**Representations of:** Friern Barnet & Whetstone Residents' Association, 14 Bethune Avenue, Friern Barnet, London N11 3LE

**Planning Inspectorate appeal reference number:** APP/N5090/W/21/3289161

**Address of the appeal site:** Barnet House, 1255 High Road, London N20 0EJ

**These representations are on behalf of Friern Barnet & Whetstone Residents' Association (FBWRA).**

*Plan 1- 10 minute walk parking survey area (red edging) an 2 minute walk area (edged and hatched blue)*

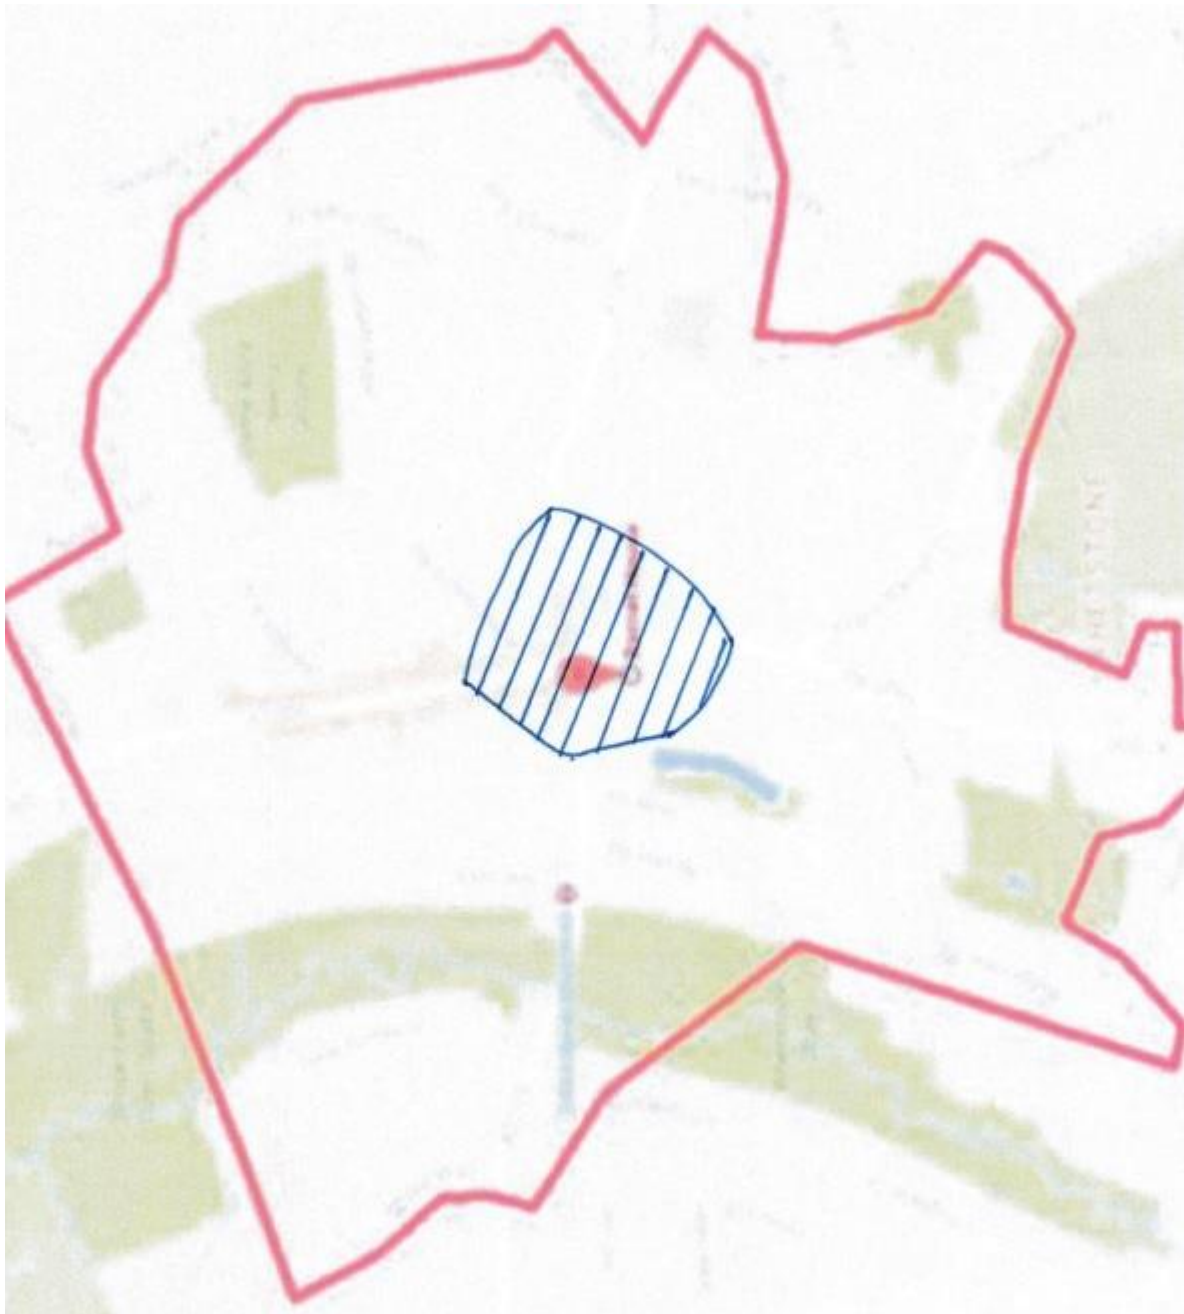
The Lambeth Methodology is that for residential developments the survey area “*generally covers an area of 200m (or a 2 minute walk) around a site.*” So, why did the 2017 and 2022 parking surveys cover parking availability within a 10-minute walk of Barnet House- an area approximately 25 times bigger- and a bigger area will inevitably throw up more parking places!

Why is there a departure from the standard methodology? We have reviewed other parking surveys provided to the Council in recent years and have not found any other cases where the survey area was extended beyond the 2 minute walk distance contemplated by the Lambeth methodology. What were the apparently unique circumstances that justified a 25 fold increase in the extent of the parking survey area – in 2017 (the original survey) - the explanation given for the same treatment for the 2021 survey was “consistency.”

Our Plan 1 (below) is a copy of a plan provided to us by the Council showing the agreed parking survey area (10minute walk) bounded by a red line. We have added, edged and hatched blue, our estimate of the extent of a 2-minute walk survey area as contemplated by the Lambeth Methodology. Clearly- bigger area- more parking spaces- easier to argue adequate parking availability. Why was this agreed?
